# 68-88 GREEN STREET CREMORNE

68-88 GREEN ST, CREMORNE VIC 3121  
VCAT REF NO. P1277/2019

**Attachment 1 - PLN18/0913-6 - 68 - 88 Green Street Cremorne - VCAT amended plans**

From Dwg A10.003:

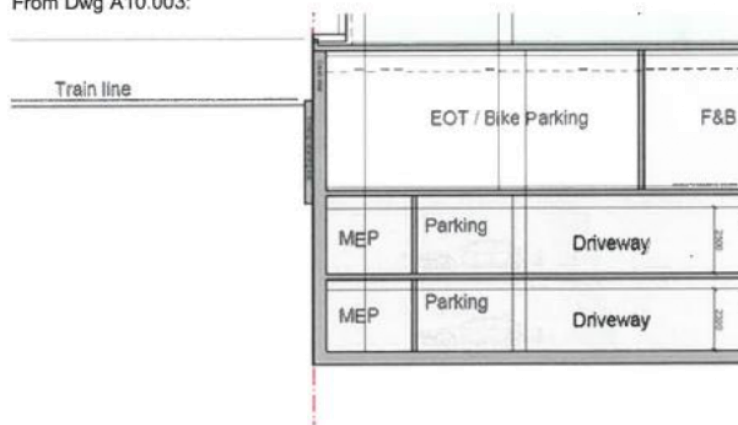
12. The rear of the building includes a ledge of 600mm wide including a drop of 2360mm into the rail reserve. This raises several concerns:
- (a) How will this construction be managed to avoid disruption to rail services? (It is expected that with construction against the rail reserve equipment, personnel etc will need to access the reserve, impacting rail services).

- (d) Placement of the building edge in this location provides no position of safety in the event of personnel on the rail lines, as there is potential for ingress at both nearby rail bridges the failure to provide safe locations is insufficient.

- (e) The proposed design provides no space for access should maintenance / repair be needed on the building rear. Any works (including construction) will require rail operation to be halted for unspecified periods of time. This will pose a significant risk to rail operation.

From Dwg A10.003:

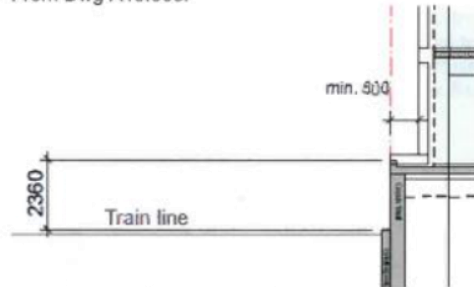
Note the limited distance from the track to the existing retaining wall (on the title, see image above)

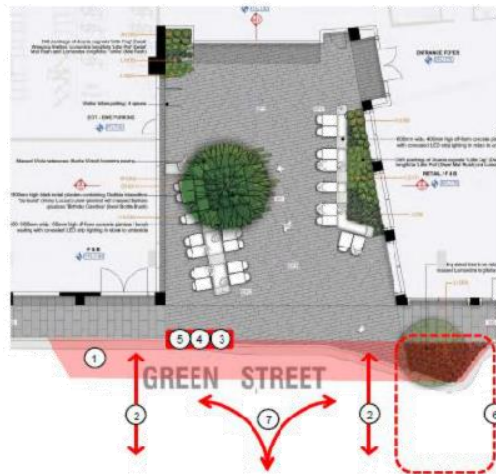
*The new public space is well located in line with Adelaide Street, and as such will benefit from views of the space from along Adelaide Street travelling west. To protect these views, improve access to the public space and provide an enhanced footpath environment, we recommend that the kerb is extended in front of the public space, as shown on the diagram below.*

1. *Extend kerb along existing 'No Standing' area, to provide a wider footpath alongside the new public space. This could accommodate new tree planting to help frame the new public space, and could consider changes to the existing Queensland Brush Box and planting. It could also include greenery and street furniture.*

2. *Provide drop kerbs to improve pedestrian connections to the footpath on Adelaide Street. If only one drop kerb is feasible, our preference is to connect to the southern footpath with better solar access.*

5. *Relocate the existing side entry pit to accommodate the kerb extension, and provide adequate drainage. Drainage analysis would be required to demonstrate that the side entry pit could be relocated in the design.*

6. *Improve the kerb alignment and planting of the existing traffic treatment.*
7. *Designs to accommodate necessary swept paths for a 10 metre truck, particularly for vehicles turning between Green and Adelaide Streets.*
